NTD-NRC-94-4142
DCP/NRC0068
Docket No.: STN-52-003

SUBJECT: WESTINGHOUSE RESPONSES TO NRC REQUESTS FOR ADDITIONAL
INFORMATION ON THE AP600

NTD-NRC-94-4142
ATTACHMENT A
AP600 RAI RESPONSES
SUBMITTED MAY 19, 1994

FIGURE 2A-24

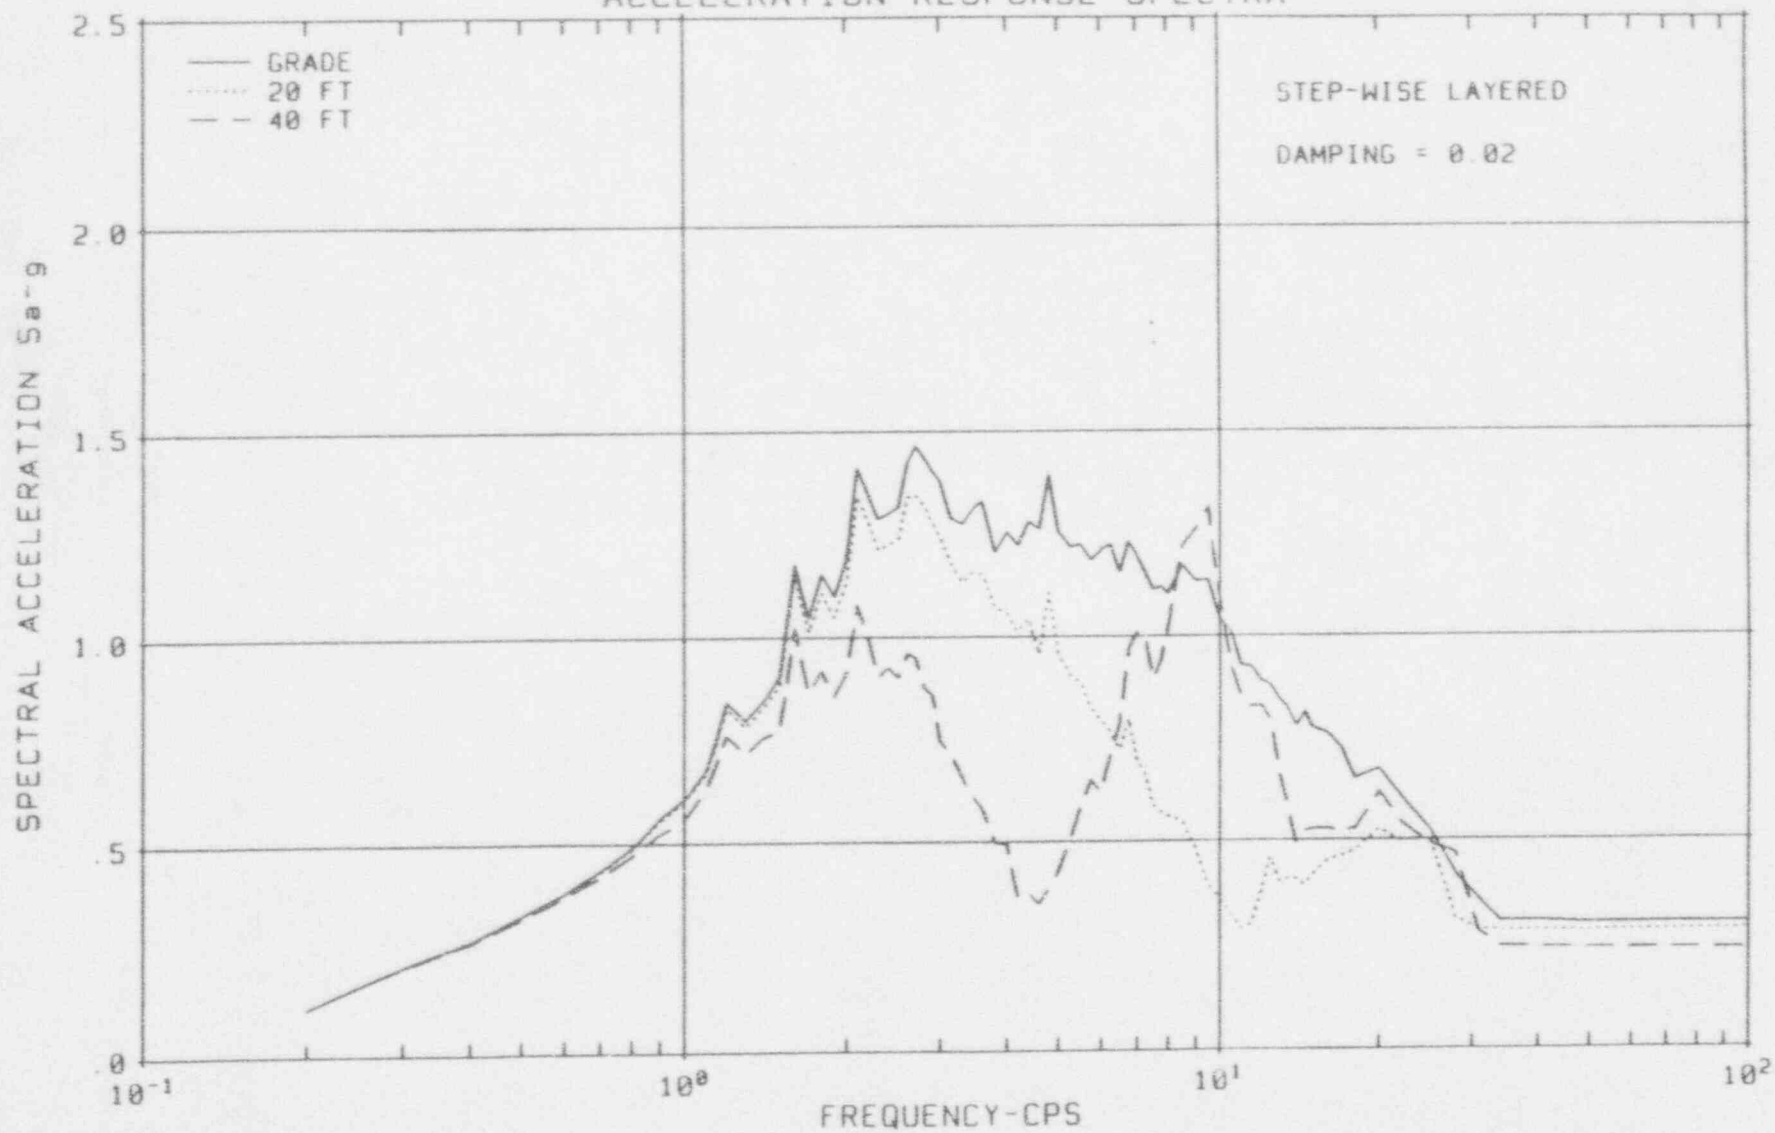
- a. In view of the above phenomenon, and referring to the response to Q231.10, justify not specifying the control motion at an actual or hypothetical rock outcrop in the above cases as well as other sites with one or more thin soil layers overlying rock.
- b. The response spectral curves in the above mentioned figures do not match the legends given in the figures. Clarify the figures.

- b. The response spectra plots were reviewed and match the legends. Attached are larger size plots of SSAR Figures 2A-20 through 2A-24 which may be easier to read.
